ZONING CHANGE REVIEW SHEET

CASE: C814-2012-0160.01 – 211 South Lamar

TO: PUD, to change conditions of zoning

EXHIBIT 1

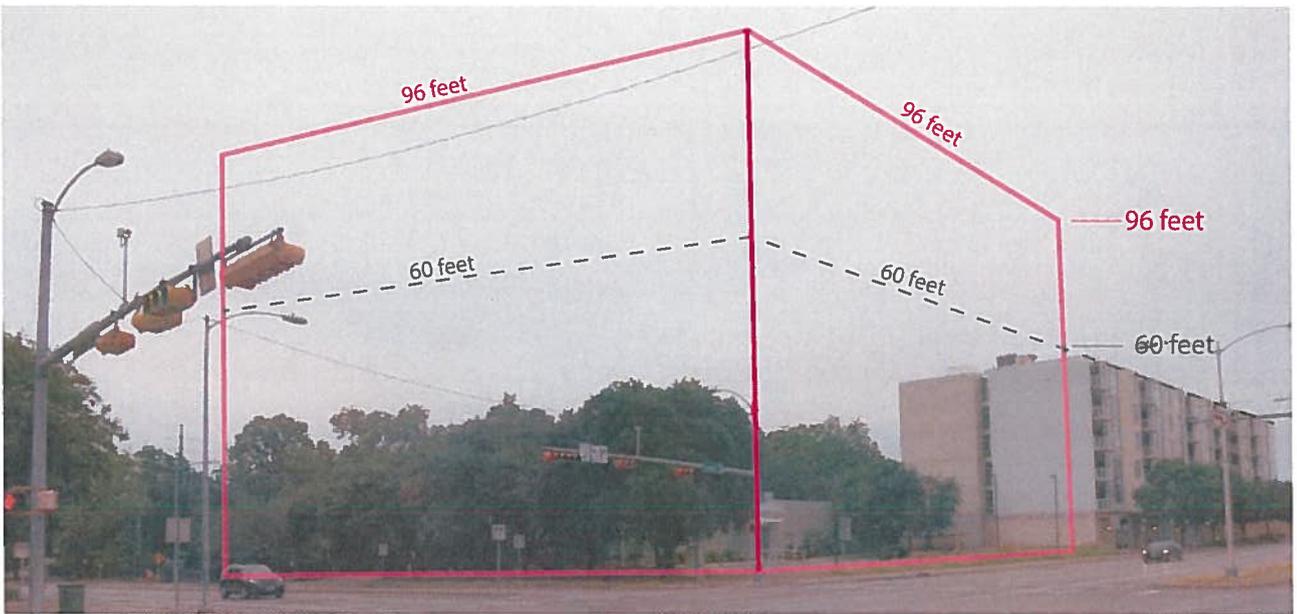
- Property Lines
- Ordinance Description of Location 96' Maximum Height for First Building Block
- Ordinance Description of Location 86' Maximum Height for Second Building Block (dashed line indicates the location is indeterminate)

EXHIBIT 2

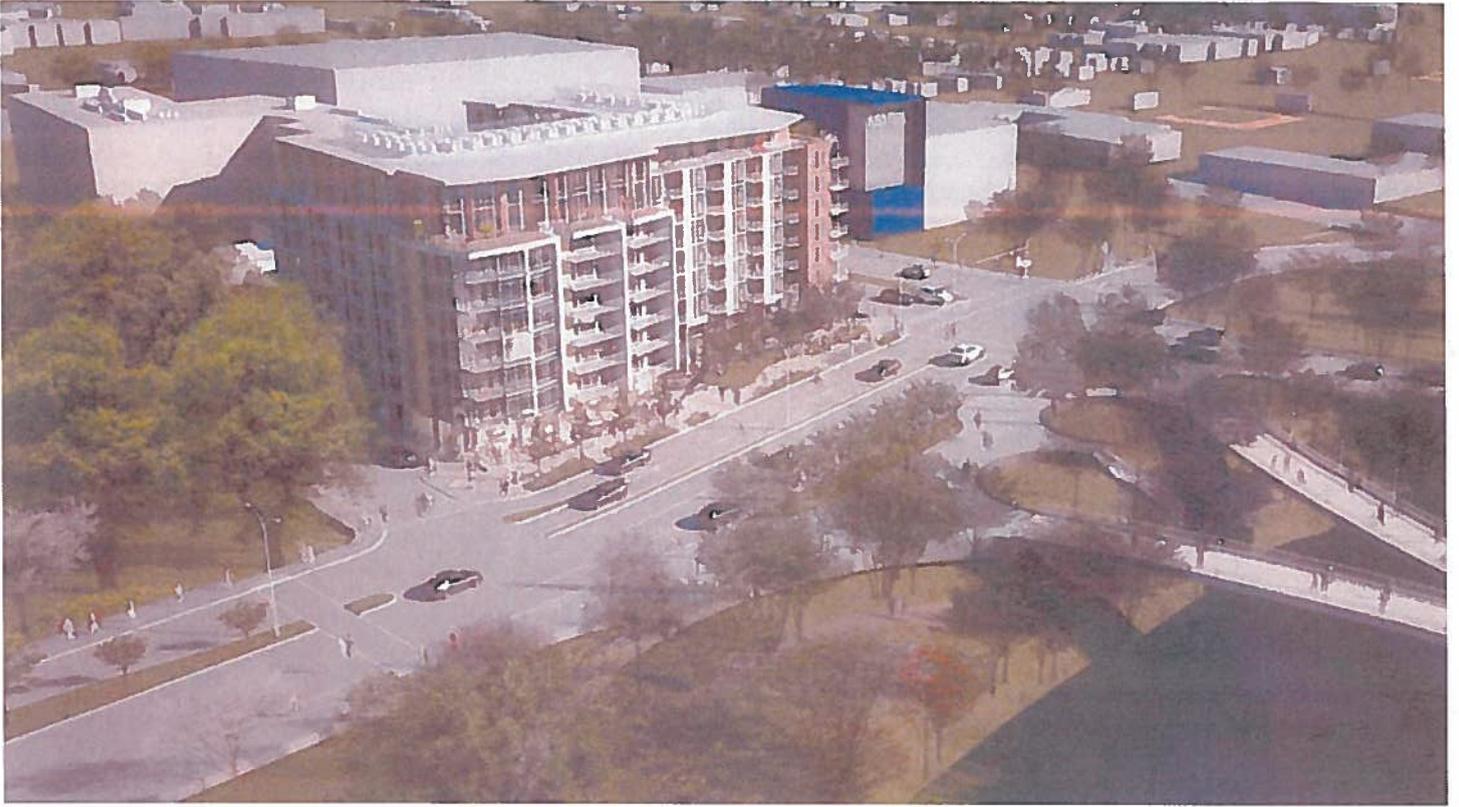
View from Butler Shores at northwest corner of South Lamar Blvd and West Riverside Dr

Most of the sky behind the trees along Lee Barton in this photo will be replaced by a view of the hotel

Most of the sky on the left three-quarters of this photo will be replaced by a view of the hotel

EXHIBIT 5

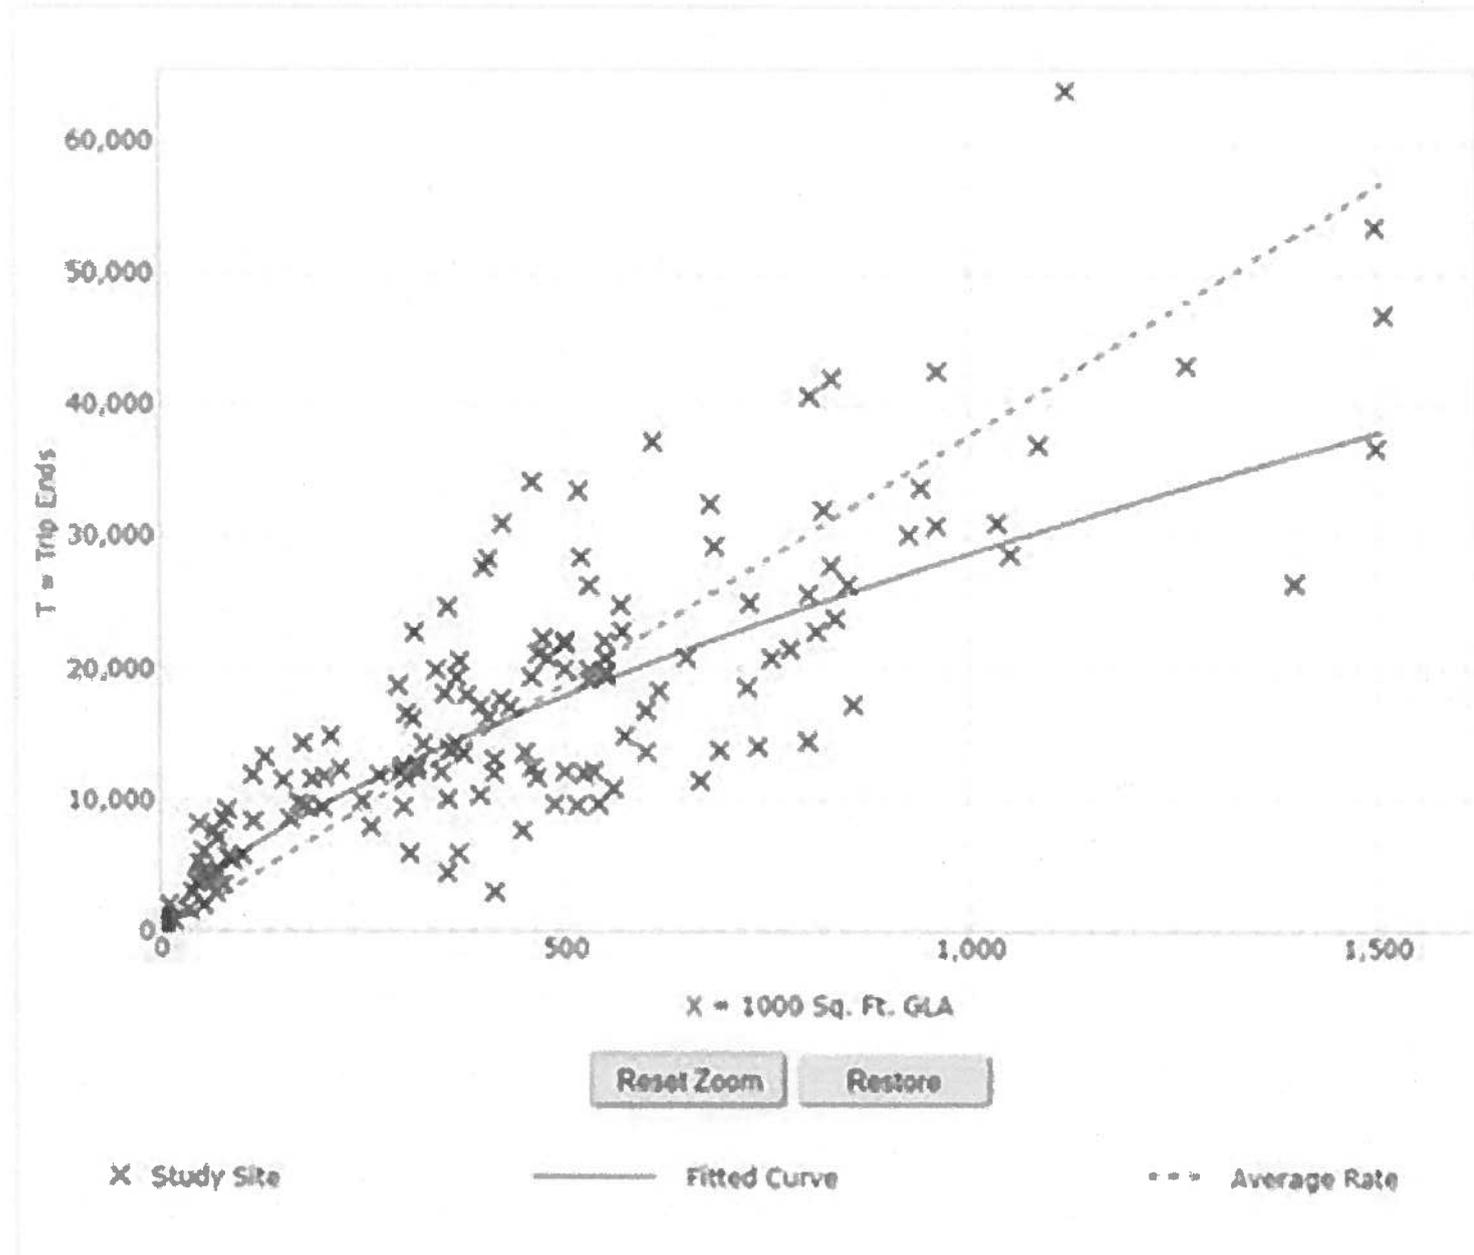
Referring to Exhibit 5, the predicted trip generation for the "shopping center" portion of the project is skewed downward by using an average rate line instead of a fitted curve. ATD said they chose the Average Rate methodology because the size of this development falls below the reasonable range of results produced via the Fitted Curve methodology. We disagree. The average rate line, from which the project's trip count was derived by ATD, is lower than any data point in the range of interest. The red lines on the graph show the size of the 211 South Lamar project. The average rate line used by ATD is lowered by projecting it through data points derived from retail centers which are so large that those points do not appear on the graph in Exhibit 5 (see Exhibit 6).
